BULLETIN

Date:	10/25/2019	Number:	CT-01	Project #:	18157
Project Name:	West Ridge SF			Attached:	16/S6.1
Subject:	CHANGING RETAINING WALL SCHEDULE ON DETAIL 16/S6.1				
Drawings Affected:	Detail 16/S6.1				
Description/Action:

CANTILEVER RETAINING WALL (WITHOUT SLAB ON GRADE CONDITION)

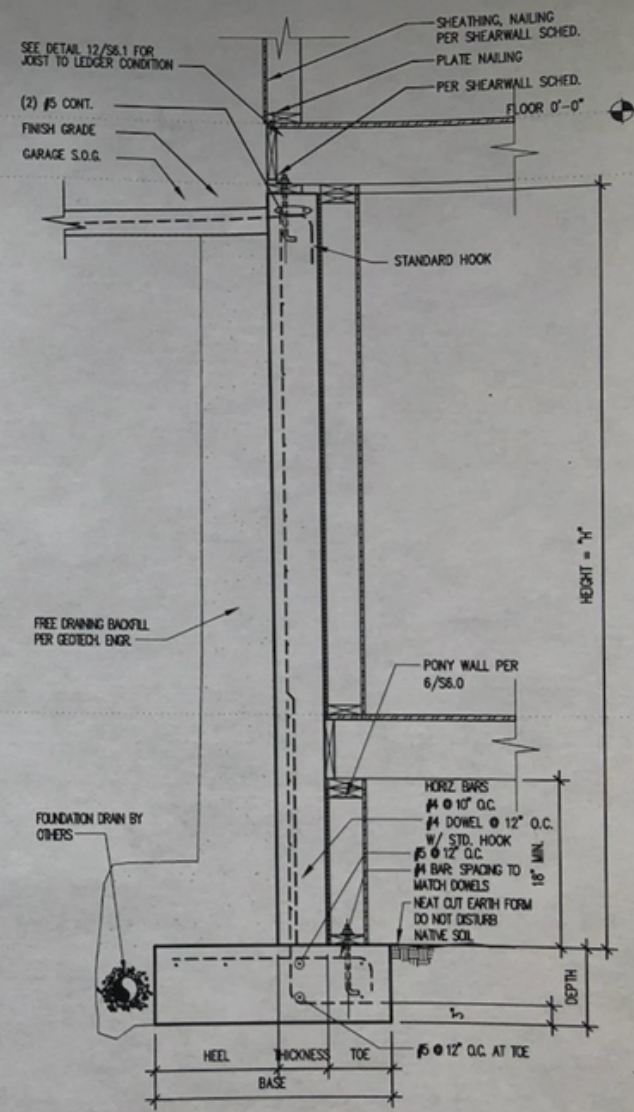
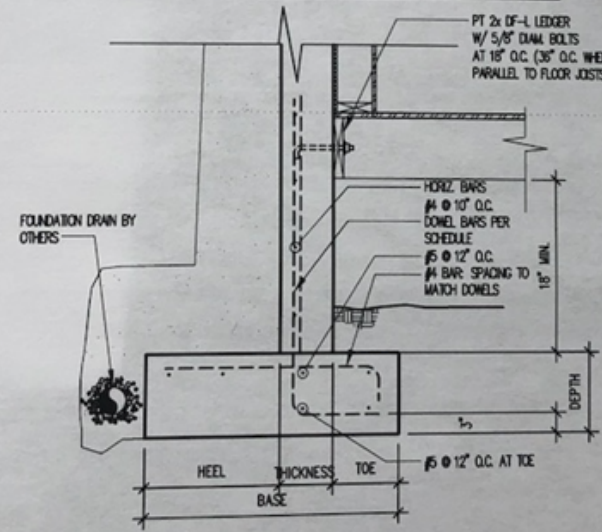
The cantilever retaining wall schedule without slab on grade as shown on detail 16 sheet S6.1 shall be replaced by the schedule attached along with this bulletin. The updated wall schedule has been calculated and verified by the engineer of record to be sufficient to carry the design loads. Detail 16/S6.1 has been updated with the new schedule and attached along with this bulletin.

CANTILEVER RETAINING WALL SCHEDULE

WALL HEIGHT	HEEL	TOE	BASE	DEPTH	DOWELS	VERT. BARS	THICKNESS
0' TO 2'-0"	0'-4"	0'-4"	1'-4"	8"	#4 @ 18"	#4 @ 18"	8"
2'-1" TO 4'-0"	0'-6"	0'-6"	1'-8"	10"	#4 @ 18"	#4 @ 18"	8"
4'-1" TO 6'-0"	1'-10"	0'-8"	3'-0"	10"	#4 @ 12"	#4 @ 12"	8"
6'-1" TO 8'-0"	3'-2"	0'-8"	4'-4"	12"	#5 @ 10"	#5 @ 10"	8"
8'-1" TO 10'-0"	4'-7"	0'-8"	5'-8"	12"	#5 @ 8"	#5 @ 8"	8"
10'-1" TO 11'-0"	5'-2"	0'-8"	6'-4"	12"	#5 @ 6"	#5 @ 6"	8"
11'-1" TO 12'-0"	5'-10"	0'-8"	7'-0"	14"	#5 @ 5"	#5 @ 5"	8"
